Subject: Rio Salado (Salt River) Environmental Restoration Project - McClintock Drive to Town Lake, Phase III, Tempe, Arizona, Review Plan Approval

REVIEW PLAN

Rio Salado (Salt River)
Environmental Restoration Project –
McClintock Drive to Town Lake
Phase III
Tempe, Arizona

PROJECT LOCATION?
AREA MAP
NOT TO SCALE

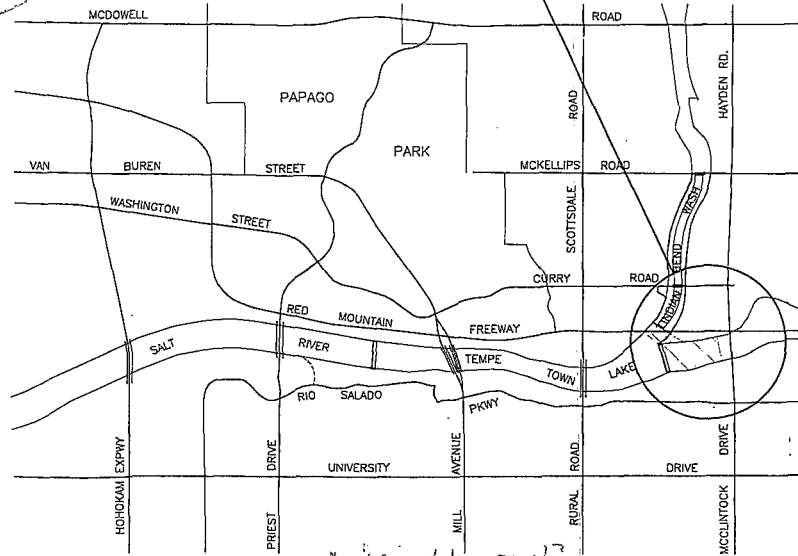
Document	Section / Sheet No.	Comment	A/E Response
Drawings	Cover Sheet	Project name on sheet and project name in title block should match exactly	Done (Cover Sheet and all other Sheets)
Drawings	Cover Sheet	Change "Area Map" to "Project Location"	Done
Drawings	Cover Sheet	Use updated title block (to be provided by Corps)	Done (Information updated per David Pham, COE)
Drawings	G-2	Name of Sheet G-2 in Index should be the same as name of sheet in title block	Done
Drawings	G-2	District File Numbers not yet assigned. (To be added by Corps)	File numbers (as provided by David Phan, COE, Los Angeles) added to each drawing sheet
Drawings	G-3	Contractor Staging Area Notes: Need to coordinate with City of Tempe to identify location of staging area. Show staging area on plans.	The staging area has not been identified by the City of Tempe. The plans include a note that the City will provide this area and that it will be within 1/2 mile of the project site.
